Docket Number:	25-OPT-02
Project Title:	Prairie Song Reliability Project
TN #:	268262
Document Title:	REV 2 DR LAND-1 Response
Description:	N/A
Filer:	Erin Phillips
Organization:	Dudek
Submitter Role:	Applicant Consultant
Submission Date:	1/19/2026 11:11:18 AM
Docketed Date:	1/20/2026

To: Lisa Worrall, California Energy Commission
From: Prairie Song Reliability Project, LLC
Subject: Response to REV 2 DR LAND-1
Date: January 19, 2026
Attachment(s):

REV 2 DR LAND-1. Please confirm if APN 3056-017-906 is within the project site. If APN 3056-017-906 is within the project site, provide a revised parcel figure that illustrates the project components located within this parcel. If APN 3056-017-906 is not located within the project site, provide a revised table of the project parcels and relevant site control information for each parcel.

REV 2 DR LAND-1 RESPONSE: APN 3056-017-906 is within the project site, and APN 3056-17-904 is not within the project site. Like APN 3056-017-905, APN 3056-017-906 is included in the project because it may be covered by an aerial easement for the potential North Gen-Tie Route. There will be no project infrastructure on these parcels and no expected perma

FIGURE 1-3
Site Layout

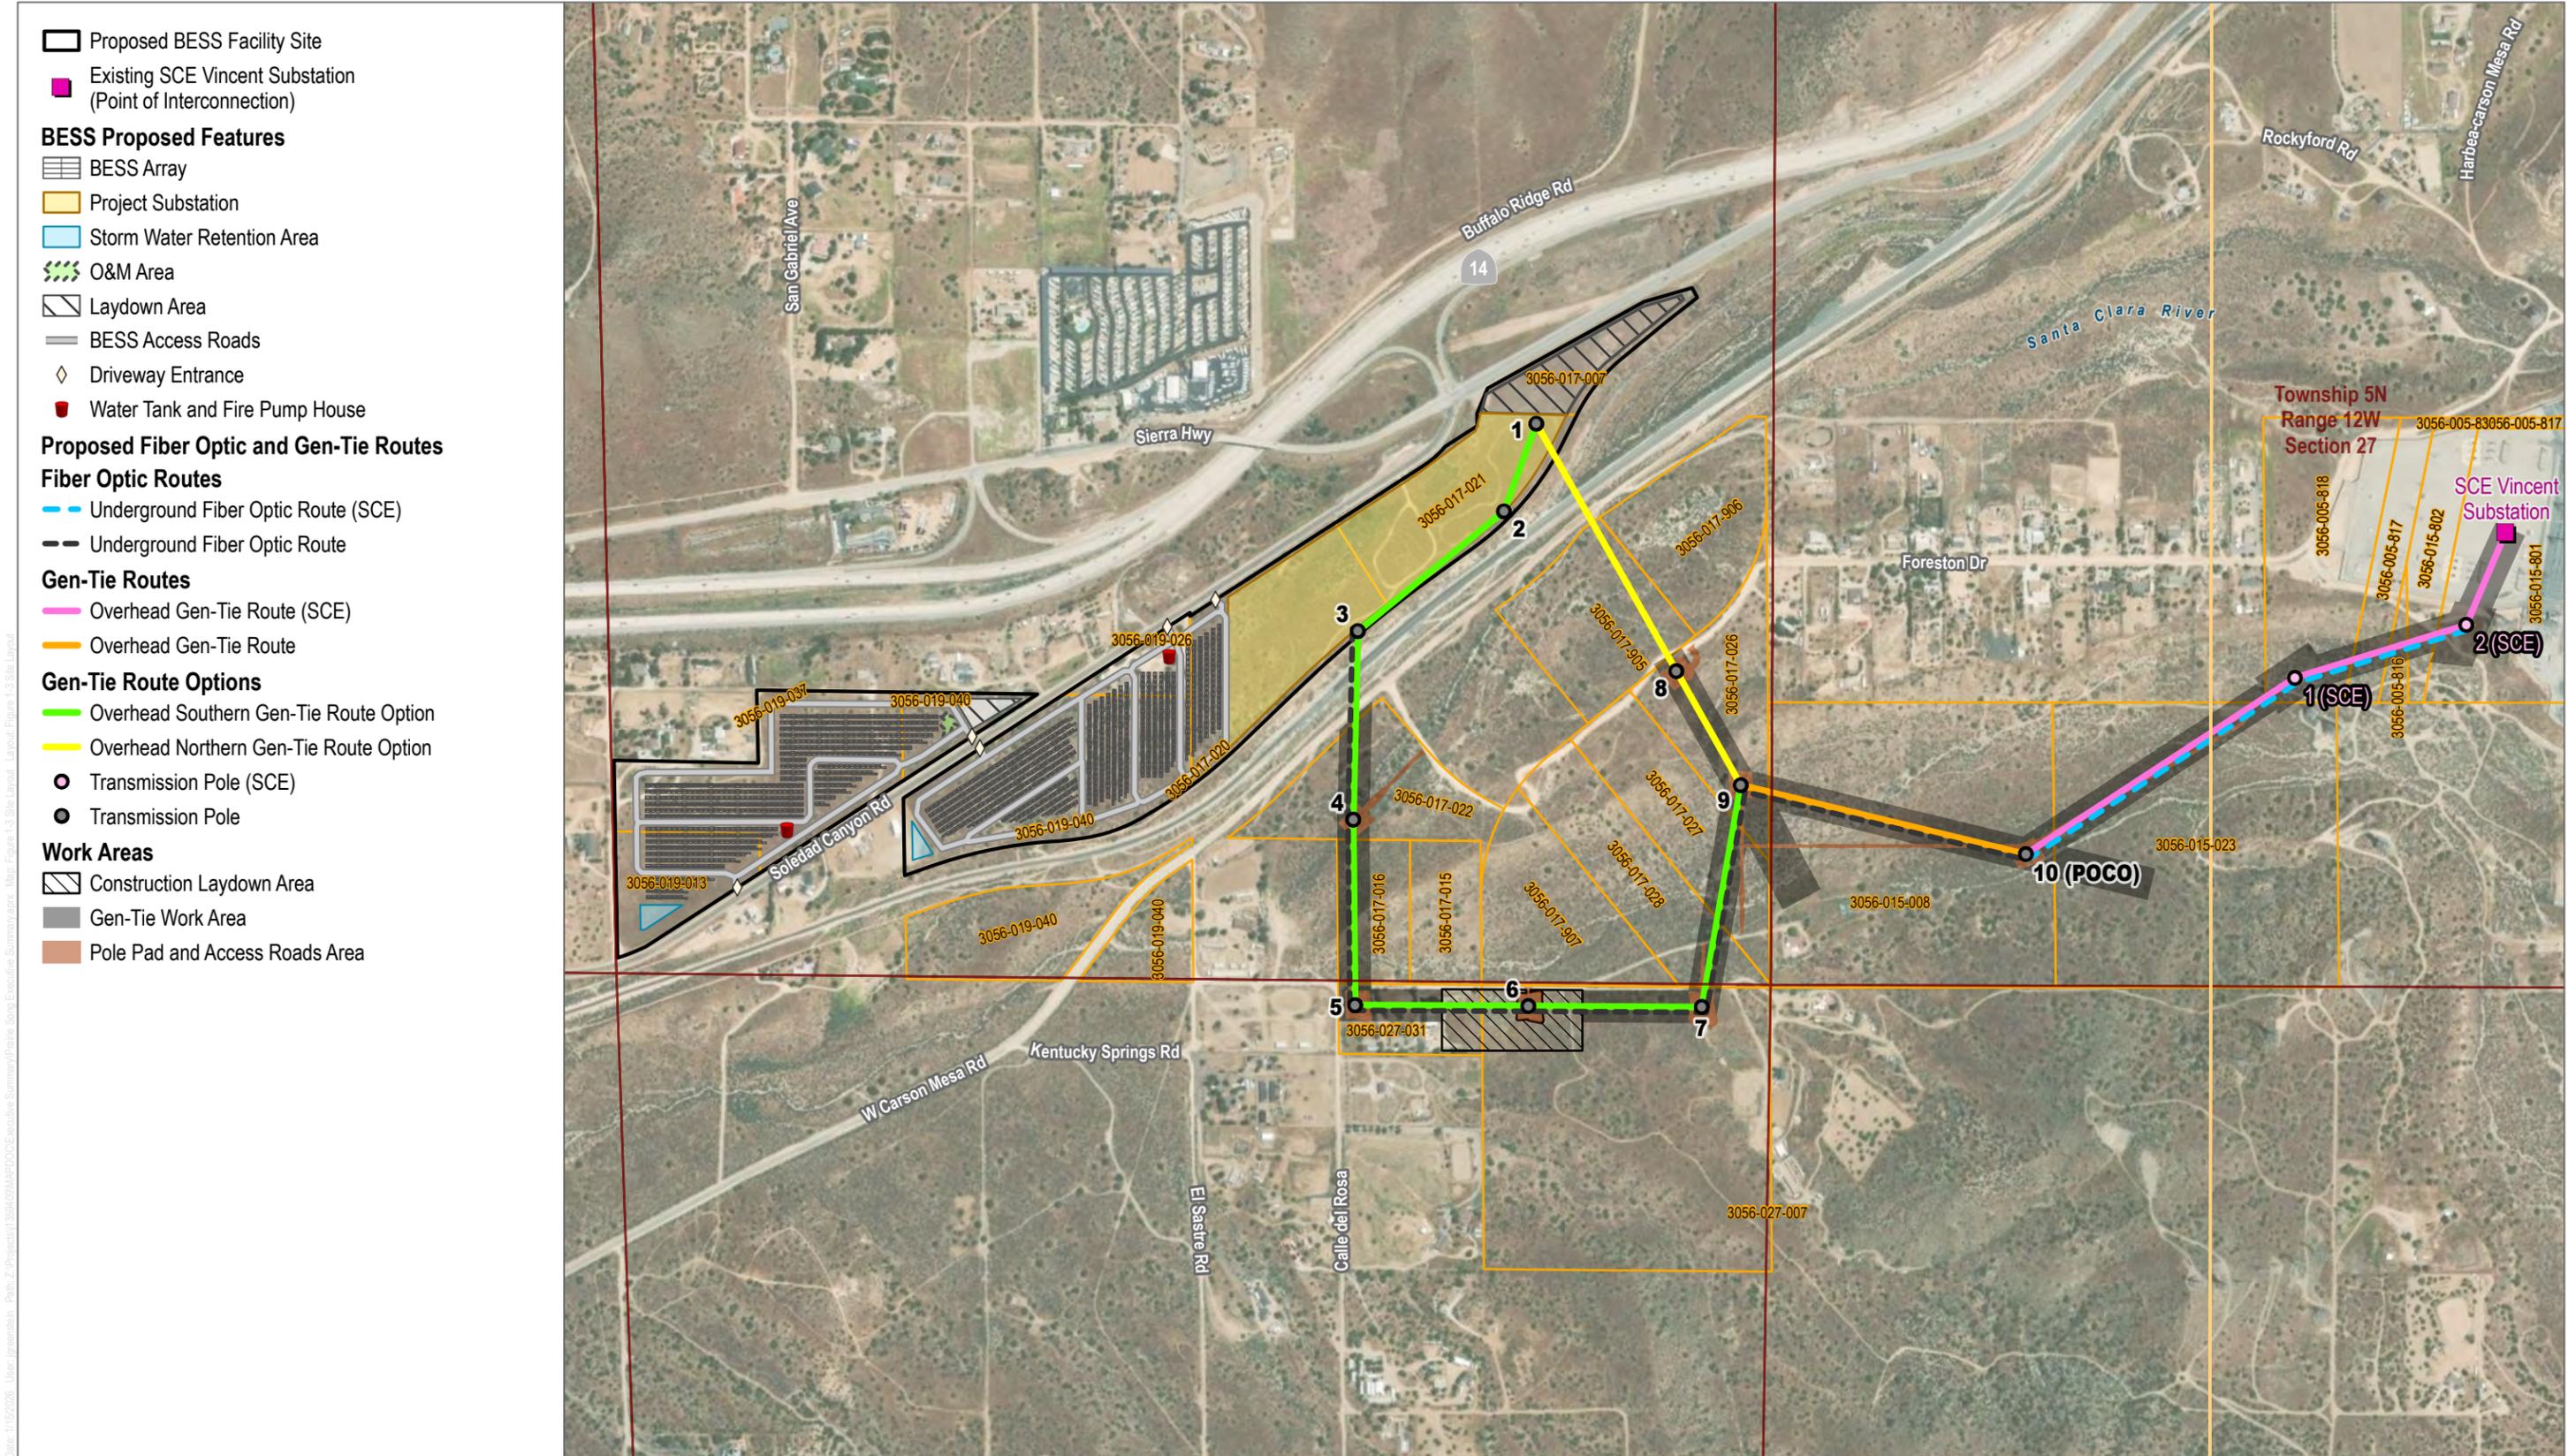
via existing roads. Please see the attached survey showing the proposed aerial easement over APN 3056-17-905 and APN 3056-17-906 (see Attachment 1 herein). To correct this error, the Applicant submits updates to the following application sections, tables, and figures. APN 3056-17-904 has been replaced by APN 3056-17-906:

- Section 1, Executive Summary (see Attachment 2 herein)
 - Table 1.1, Project Parcels
 - Section 1.4 Project Ownership
 - Figure 1-3, Site Layout
- Section 2, Project Description (see Attachment 3 herein)
 - Section 2.1, Project Location
 - Figure 2-1, Project Site Plan
- Figure 3.6-2, APN Map (see Attachment 4 herein)
